**CALIFORNIA COASTAL COMMISSION**

**STAFF REPORT: REGULAR CALENDAR**

**APPLICATION NO.:** 5-00-228

**PROJECT DESCRIPTION:** Subdivision of an existing 0.65 acre blufftop parcel into two lots of 0.45 acre/19,687 square feet (Parcel 1) and 0.20 acre/8,840 square feet (Parcel 2) in the private, locked gate community of Abalone Point. The project also involves demolition of an existing guest house. No new construction is proposed at this time.

Exhibit 1  
Hopkins proposed subdivision  
Bluff edge determination

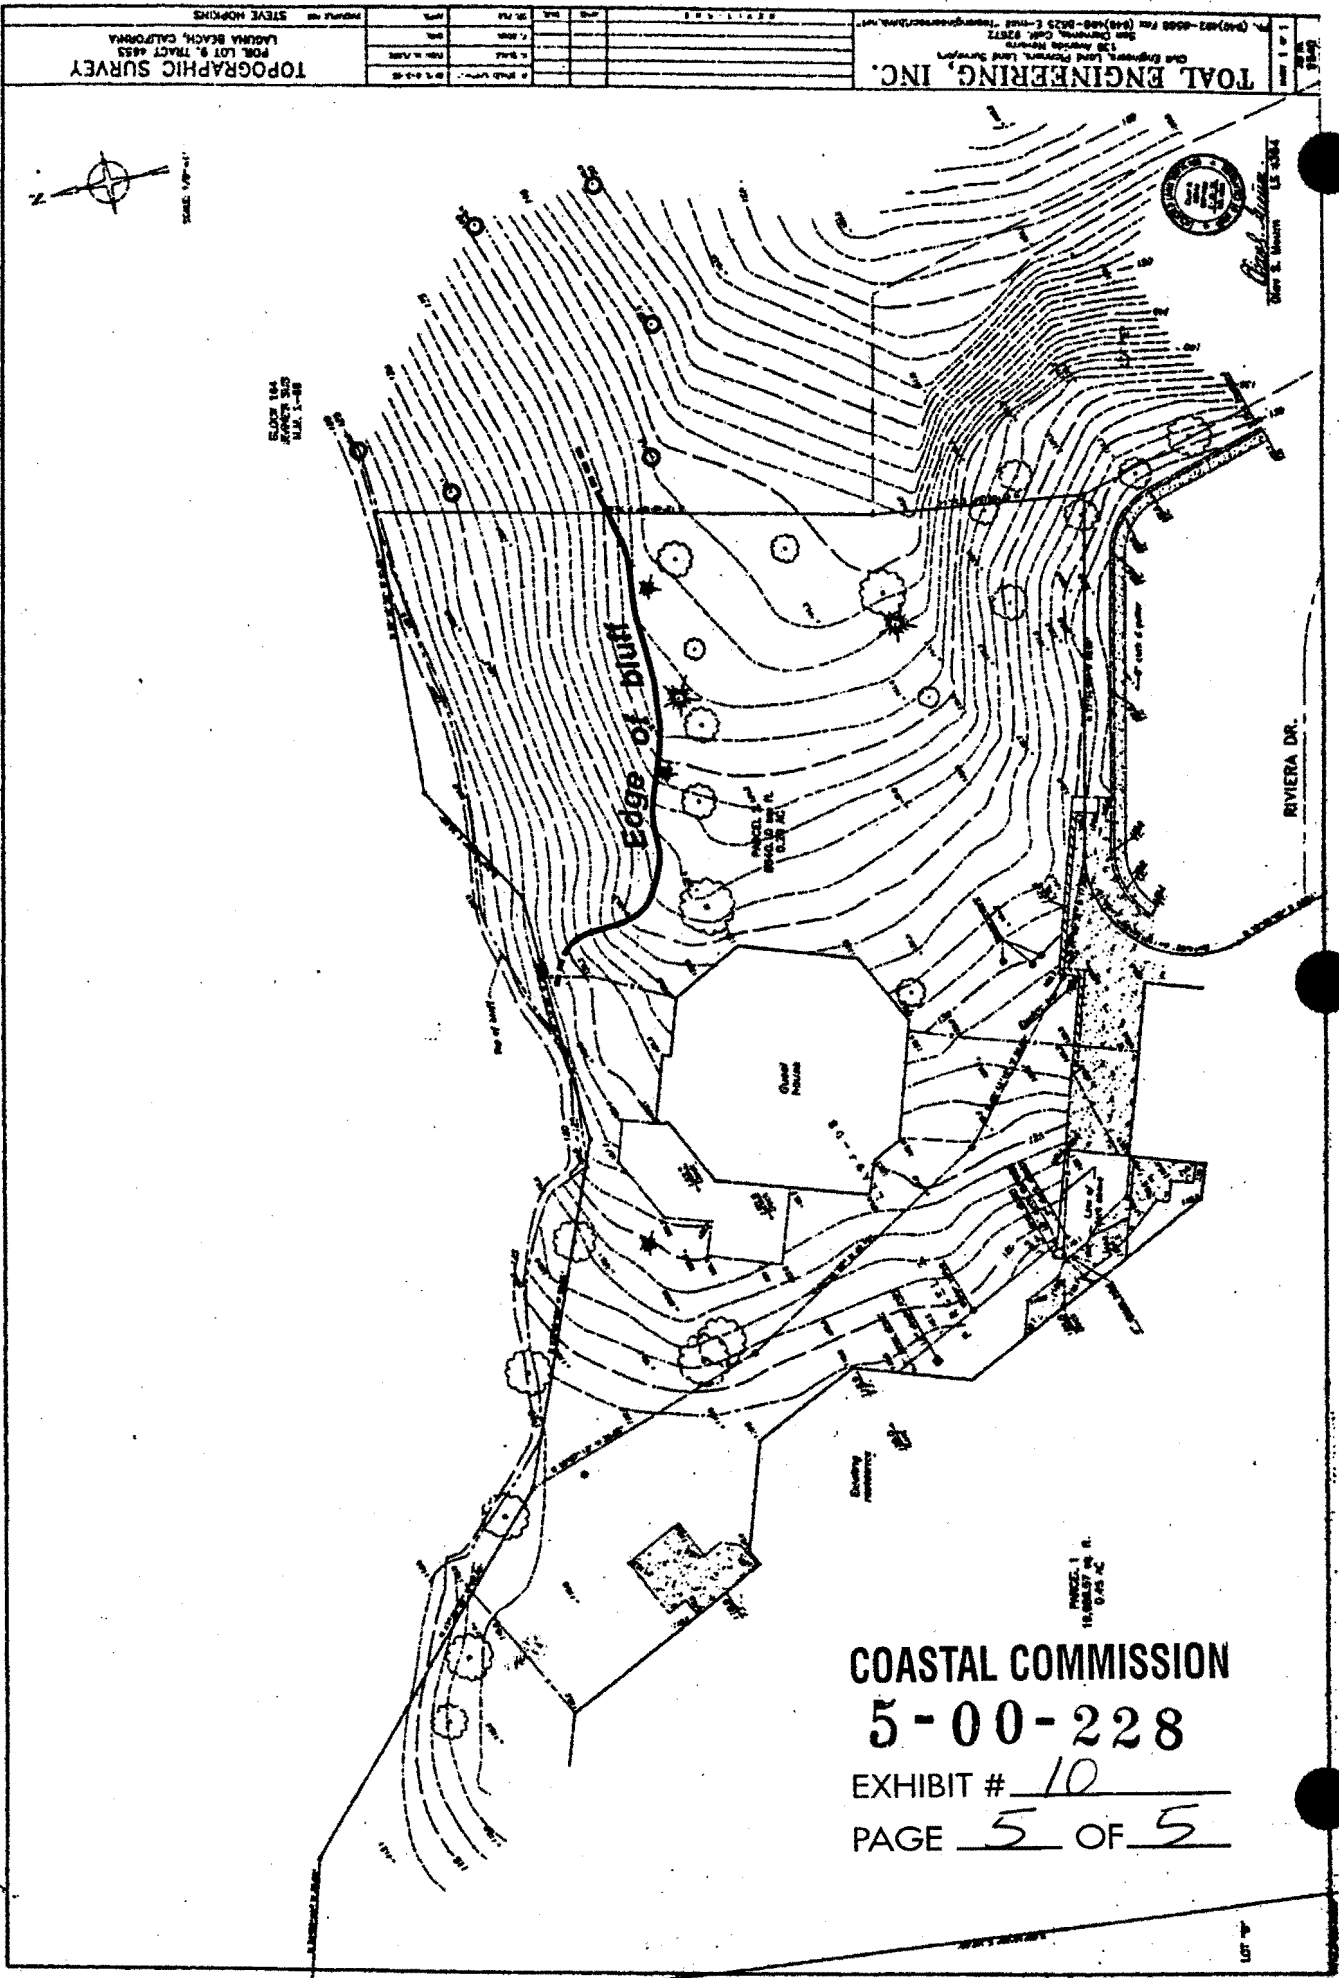
As stated in the staff geologist's memo, the upper portion of the bluff in the eastern end of proposed Parcel 2 has been rounded off and contains a "step-like" feature. Based on staff's evaluation of the site, it is apparent that the edge of the bluff curves northward to meet the steeper lower part of the bluff and tapers out east of the property, to form a continuous slope. As such, the topography of the bluff edge changes from a steep cliff face along the northern and northwestern portions of the property to a more gradual, terraced slope (i.e. "step") along the eastern portion of the property.

The bluff edge determination provided by the Commission's geologist is based on the portion of Section 13577 quoted above which states, "*In a case where there is a steplike feature at the top of the cliff face, the landward edge of the topmost riser shall be taken to be the cliff edge.*" As stated in the staff geologist's memo, "*Clearly, a step-like feature exists in the bluff profile on this part of the parcel.*" (This feature is illustrated in photographs provided in Exhibit 13.) Using the definition provided in Section 13577, the topmost riser, or inlandmost break in slope, must be used to establish the bluff edge at the subject site. The 25-foot blufftop setback must then be measured from this point.

Figure 2. Coastal Commission Bluff Edge Determination

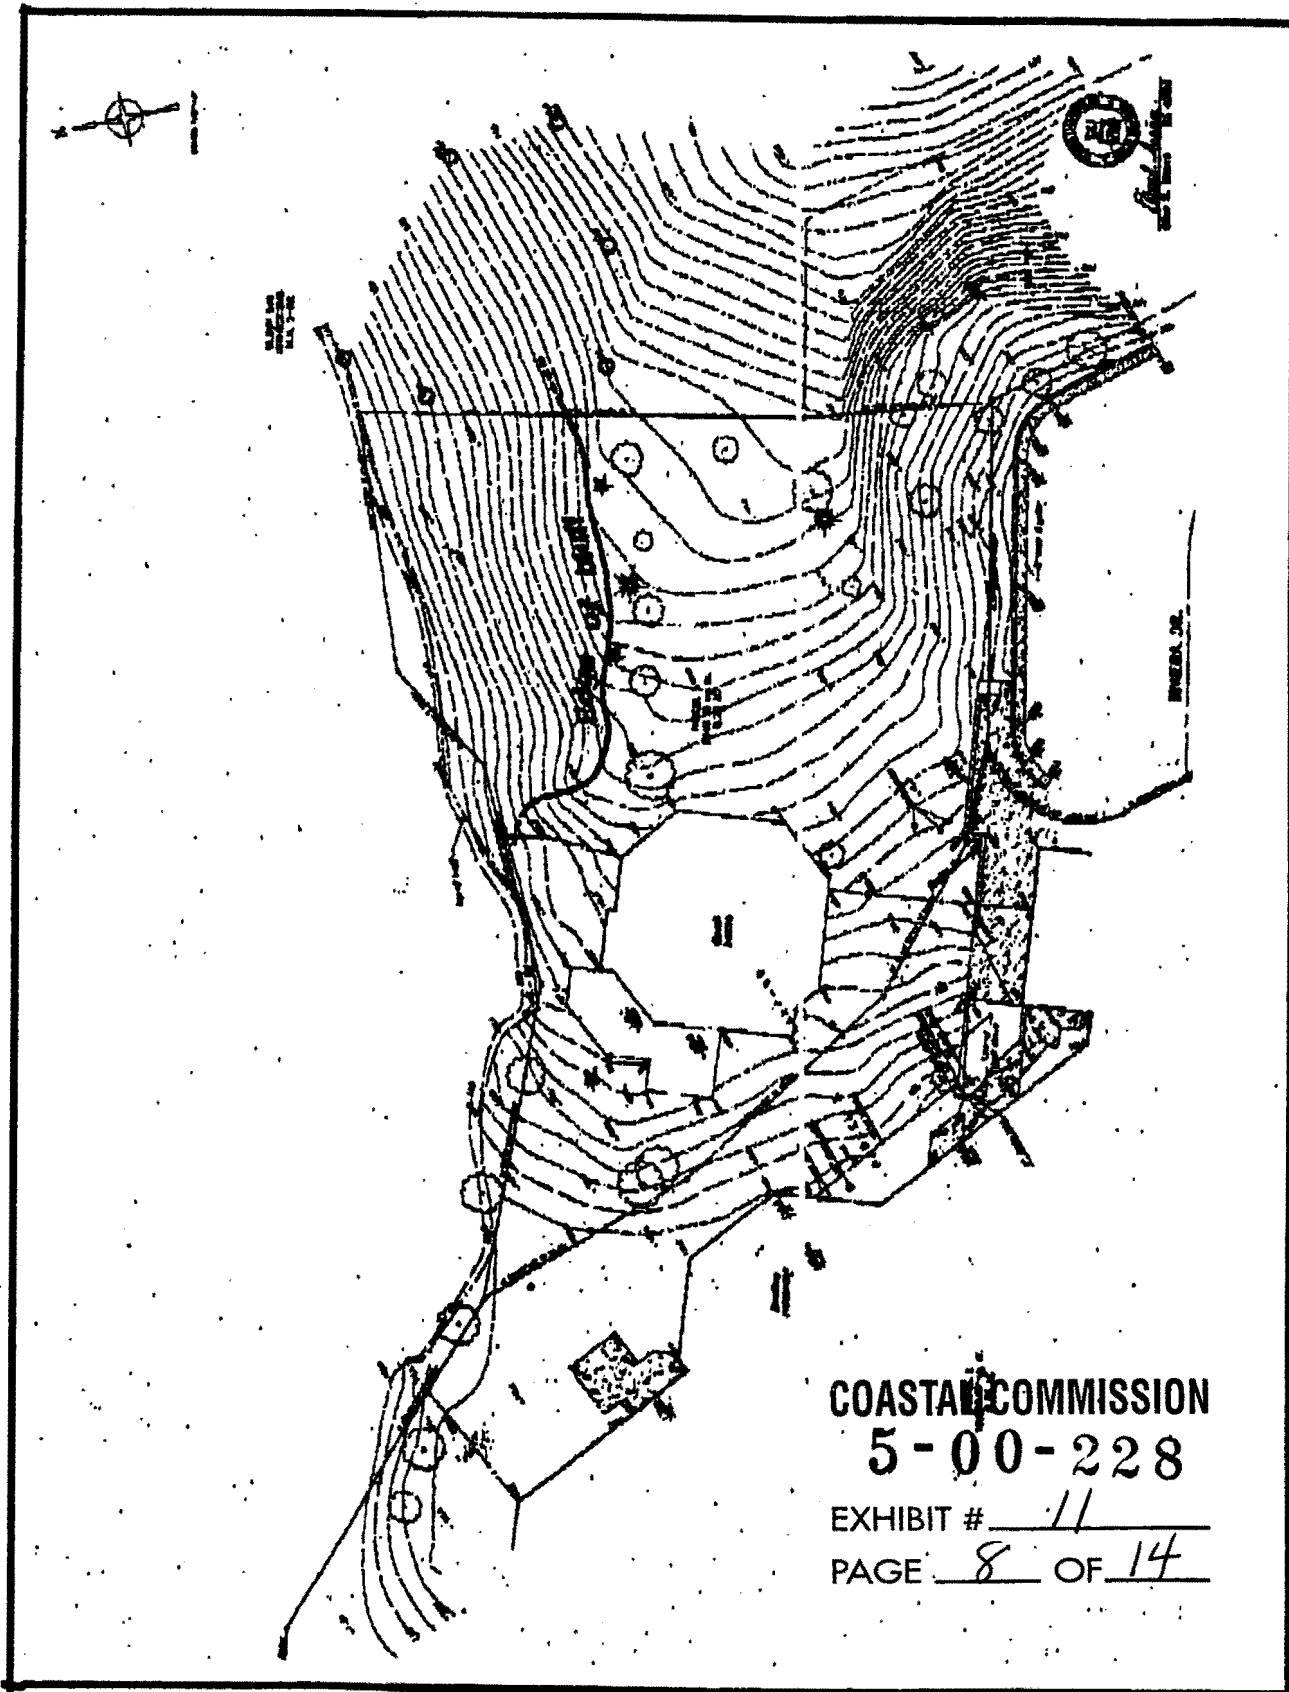
The top of bluff in the site vicinity occurs where the sea cliff, a younger and distinct geomorphic feature, intersects the adjoining older landforms, the marine terrace surface and/or the adjoining preexisting hillside and ridgeline. On the basis of the preceding discussion of geomorphology, geologic history, and geologic definitions, the top of bluff is correctly assigned at the intersection of the individually distinct landforms which are different in both age and genesis. This technically correct top of bluff is graphically depicted on the attached photographs as is the incorrect interpretation of Mr. Johnsson. Geomorphic features and geologic units are also labeled on the photographs. Mr. Johnsson's depiction of the bluff edge is also presented on Figure 2.

landforms meet. Mr. Johnsson's interpretation and designation of the bluff top is not a continuous feature, as it terminates in the middle of the northerly facing slope of the older "rounded hilltop" above the marine terrace surface easterly of the site (Refer to Figure 2). Mr. Johnsson admits his designated bluff edge becomes difficult to identify in this area because the topographic data depicts the existing gradual uniform slope descending from the hilltop above. On this basis it is apparent that his interpretation and designation of the bluff top is incorrect.

**Top of Bluff**

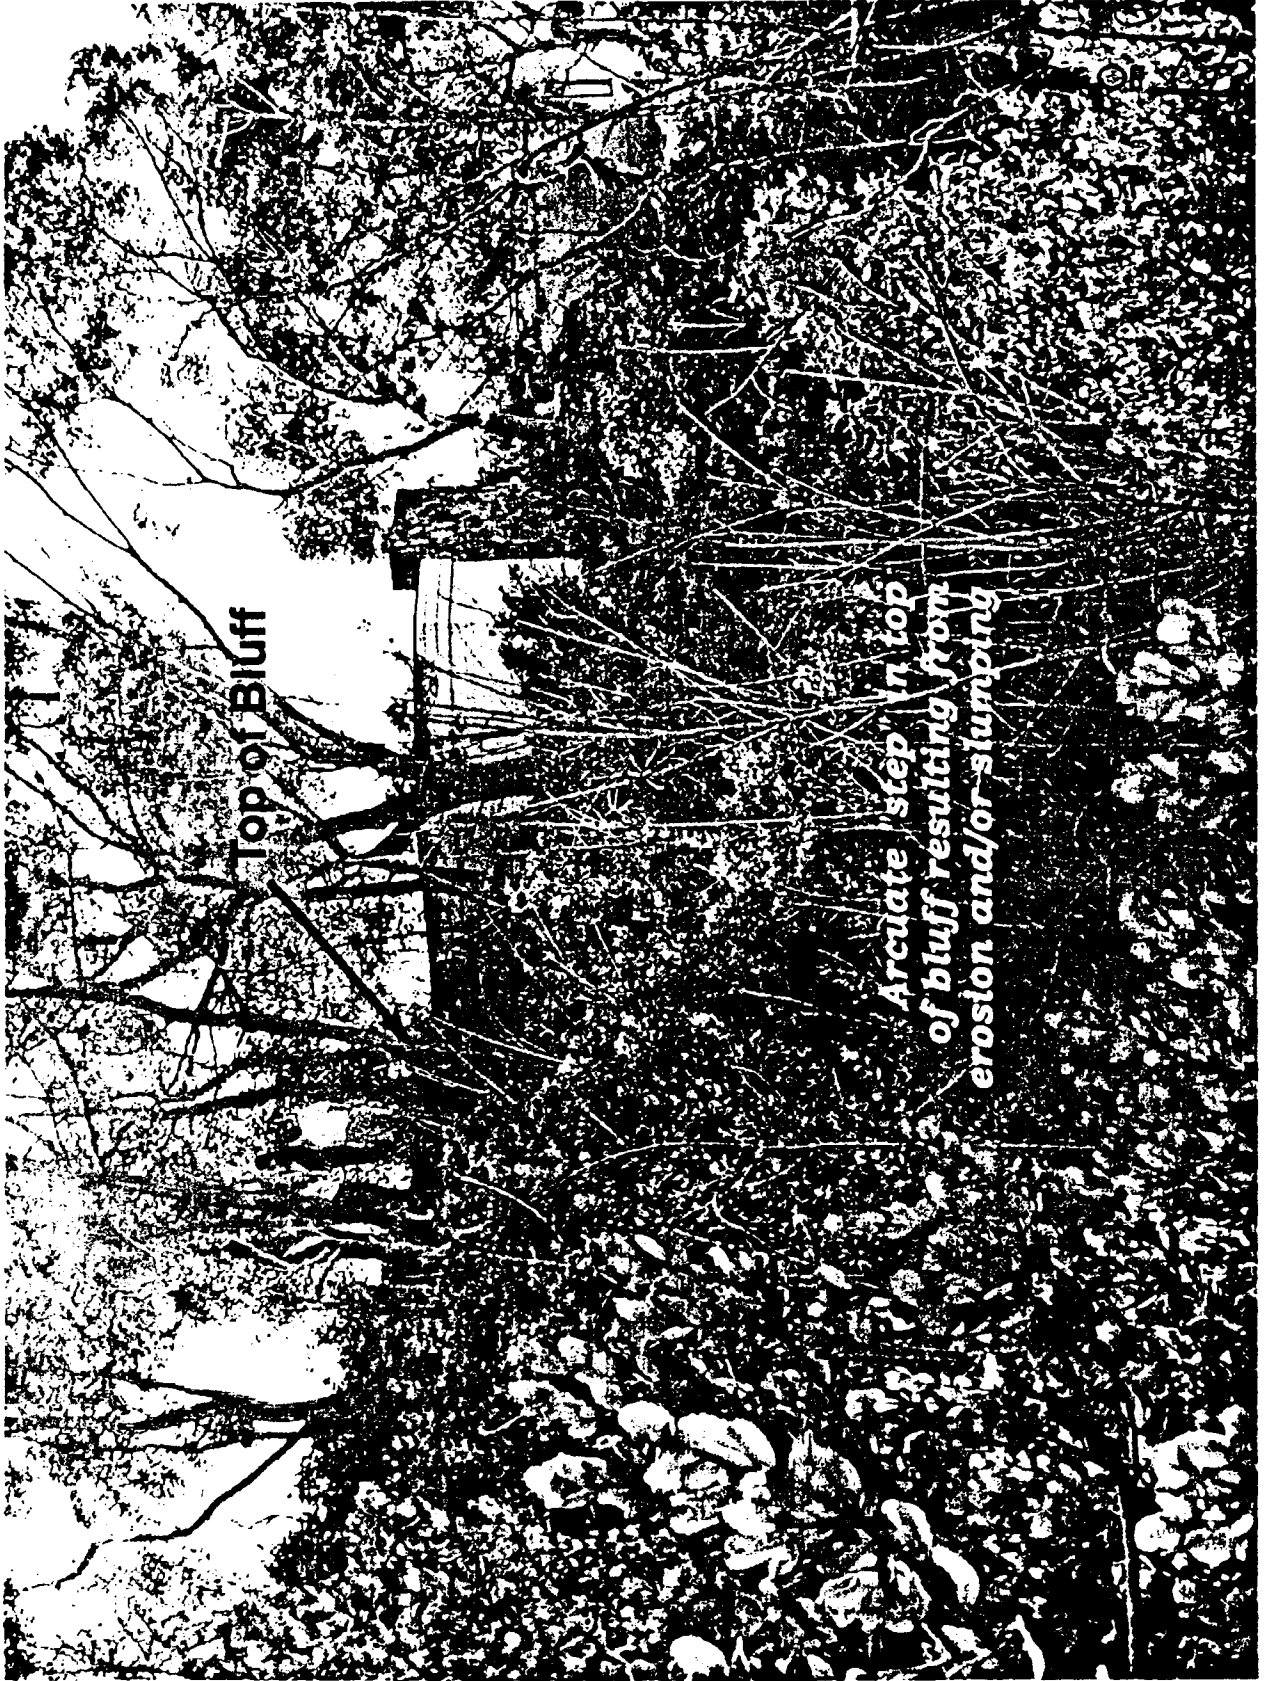
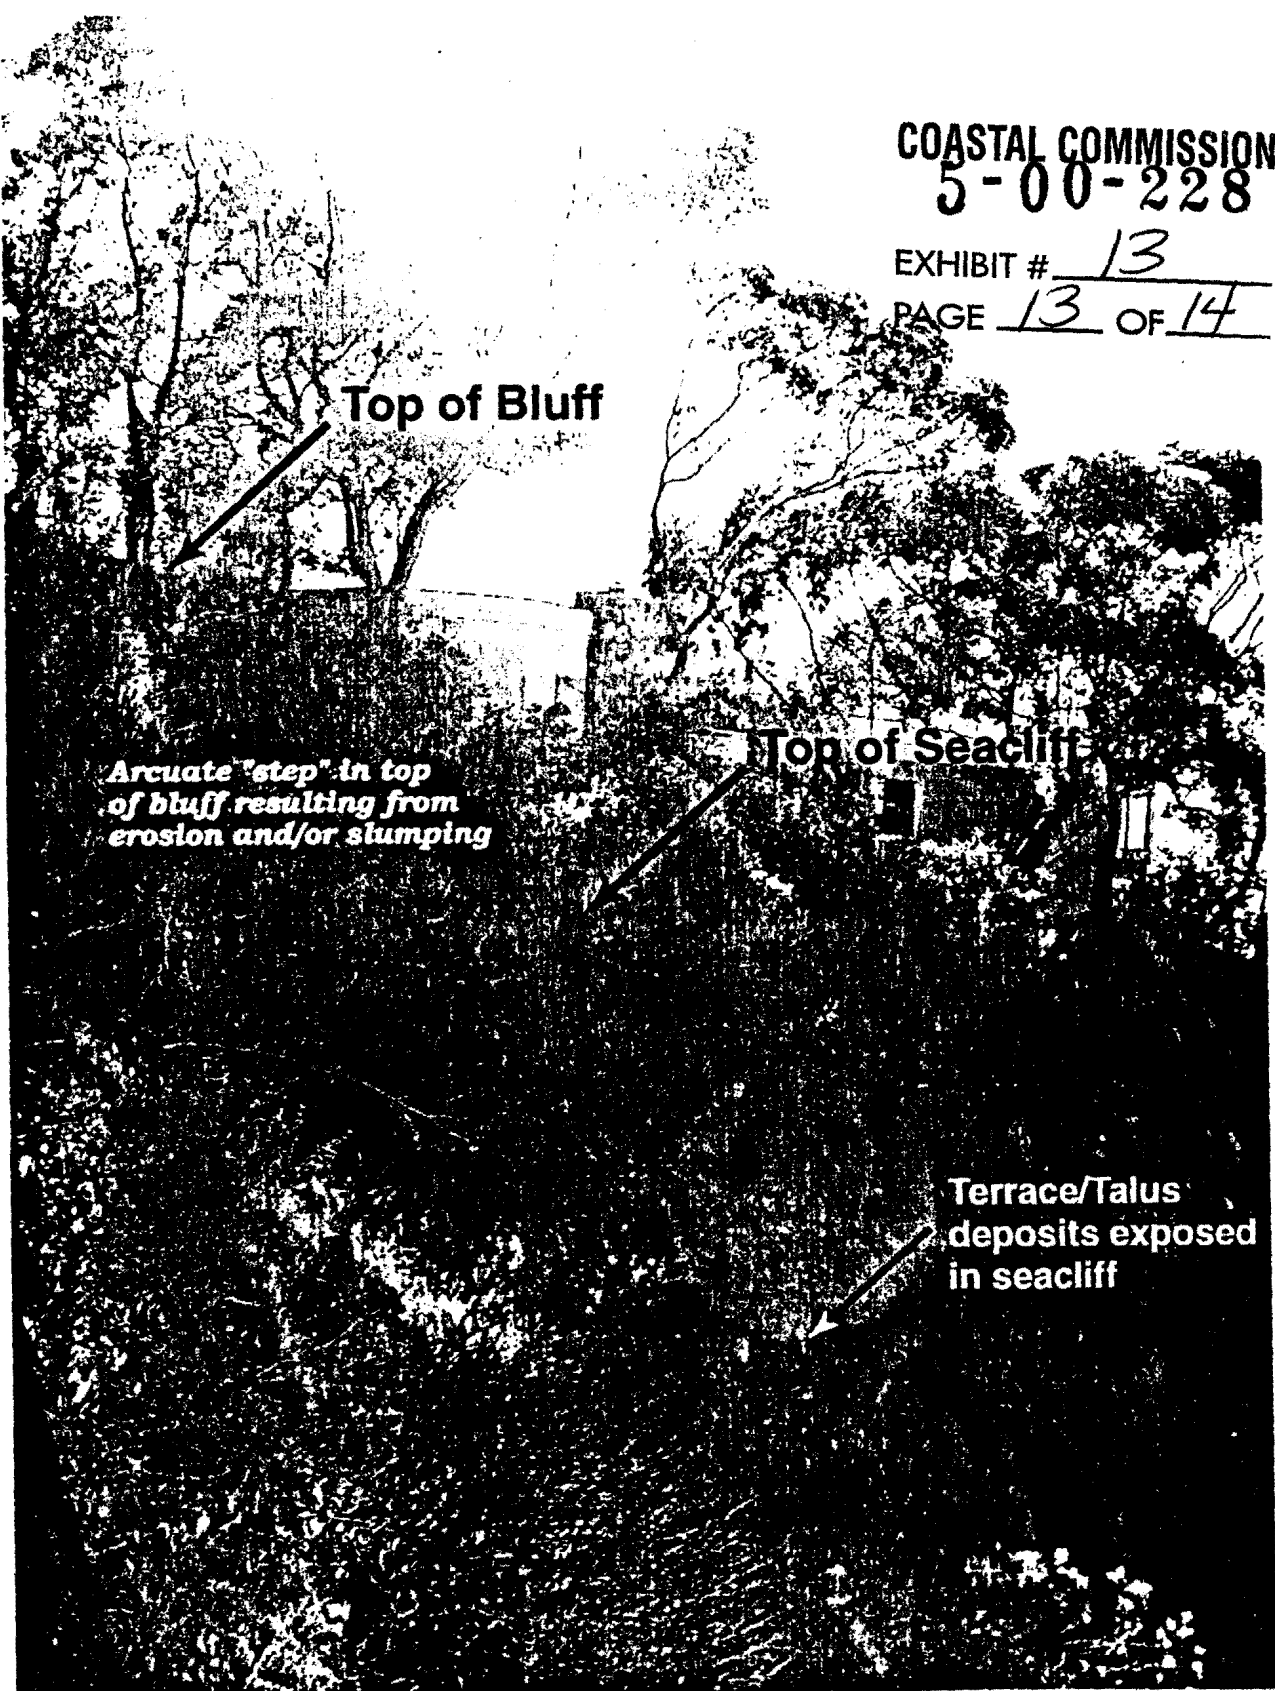
The photographs submitted by the applicant (Exhibits 1-4) clearly indicate the arcuate feature in the eastern portion of the parcel, as well as a similar feature in the Monterey Formation and marine terrace deposits east of the site. I have annotated these photographs to indicate the location of these features. Mr. Childs relates the feature on the subject parcel to an early episode of erosion contemporaneous with the formation of the uplifted marine terrace in the area, and pre-dating the formation of the seacliff below. I would suggest an alternative explanation: that the terrace or talus deposits still found in patches on this topographic feature (and identified in the Geofirm report of 26 September 2000—reference 3 of my 24 October memorandum) have been eroded or slumped away from the cliff at this point, resulting in the arcuate landform now found. Mr. Childs has argued to me (verbal communication, ) that the presence of a residual soil on this feature (test pit 2 of the 26 September 2000 report) argues against any recent erosion. If actual residual soil is present, I would agree with this argument. The material encountered at the top of test pit 2 could, however, be colluvium (Earth materials transported down slope by soil creep or other slope processes) or even additional terrace deposits, and not residual soil. Drawing a distinction between these materials
